Subject: UniStar Nuclear Energy, NRC Docket No. 52-016
Response to Request for Additional Information for the
Calvert Cliffs Nuclear Power Plant, Unit 3,
RAI 402, Information Systems Important to Safety

**Response to NRC Request for Additional Information
RAI 402, Question 07.05-3, Information Systems Important to Safety,
Calvert Cliffs Nuclear Power Plant, Unit 3**

RAI No. 402

FIGURE 1

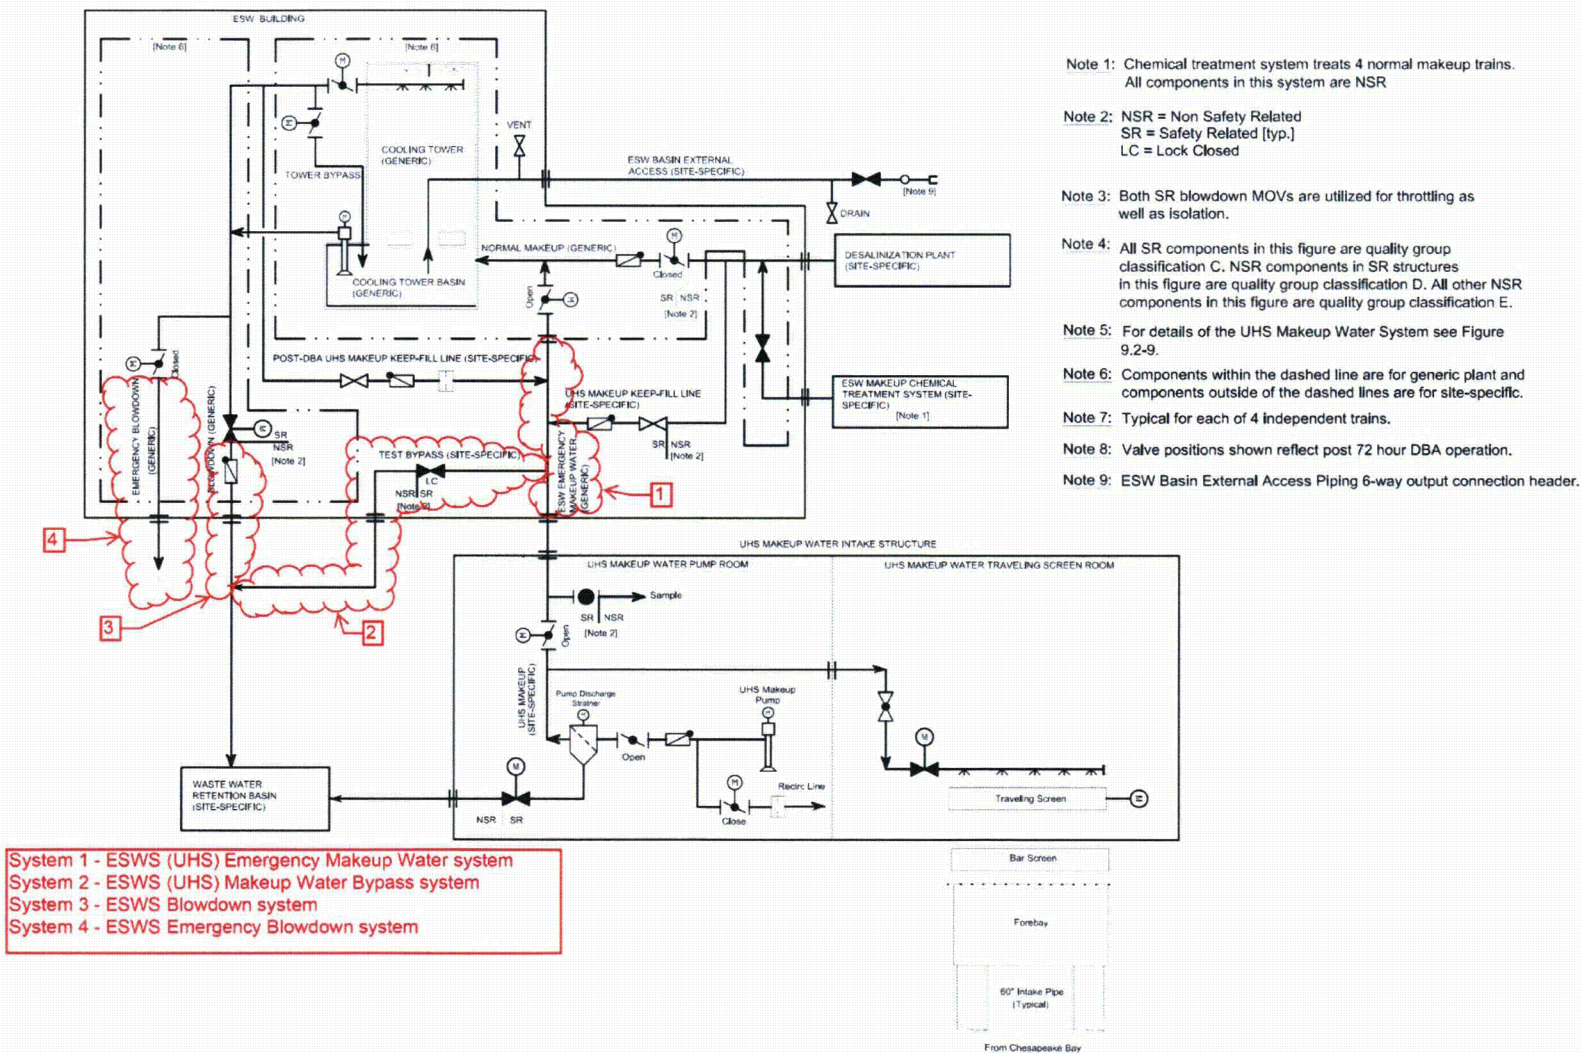
Provide additional information that describes and explains how the safety-related instrumentation and control (I&C) systems for site-specific systems, such as the Ultimate Heat Sink (UHS), address NRC requirements. 10 CFR Part 50, Appendix A, General Design Criteria 13 requires, in part, that instrumentation be provided to monitor variables and systems over their anticipated ranges for normal operation, for anticipated operational occurrences, and for accident conditions. In RAI 325, Question 07.05-1, the staff noted that while the UHS is safety-related, the staff was not able to identify information in Chapter 7 of the Calvert Cliffs Nuclear Power Plant Unit 3 (CCNPP Unit 3) Final Safety Analysis report (FSAR) that describes the UHS I&C. From information located in the ITAAC, and Chapter 9 of the CCNPP Unit 3 FSAR, the staff identified the following site-specific systems, for which the related I&C design information was not found in Chapter 7 of the CCNPP Unit 3 FSAR. These systems include: UHS makeup water intake structure ventilation system (initiated automatically), UHS makeup water system (each division can be initiated manually), essential service water system (ESWS) normal makeup system, ESWS emergency makeup water system, ESWS makeup water bypass system, ESWS blowdown system, and ESWS alternate blowdown system.

The staff requests that the applicant state the I&C system that provides control to each of the following systems: ESWS (UHS) Emergency Makeup Water system, ESWS (UHS) Makeup Water Bypass system, ESWS Blowdown system, and the ESWS Emergency Blowdown system. If an I&C system does not provide control, discuss how control is provided.

Refer to the attached Figure 1 (excerpt from Calvert Cliffs Nuclear Power Plant (CCNPP) Unit 3 FSAR Figure 9.2-3). The four systems that are described in Staff's question above, i.e., Essential Service Water System (ESWS) Ultimate Heat Sink (UHS) Emergency Makeup Water system, ESWS (UHS) Makeup Water Bypass system, ESWS Blowdown system, and the ESWS Emergency Blowdown system are indicated by the boundary labels 1, 2, 3 and 4, respectively. As shown, in Figure 1, these systems consist of only piping and manual isolation valves or check valves, which do not require any I&C control. Therefore, these subsystems are not controlled by an I&C system. Since these systems do not require I&C control or additional information, there is no impact to FSAR Chapter 7 and site-specific ITAAC Tables.
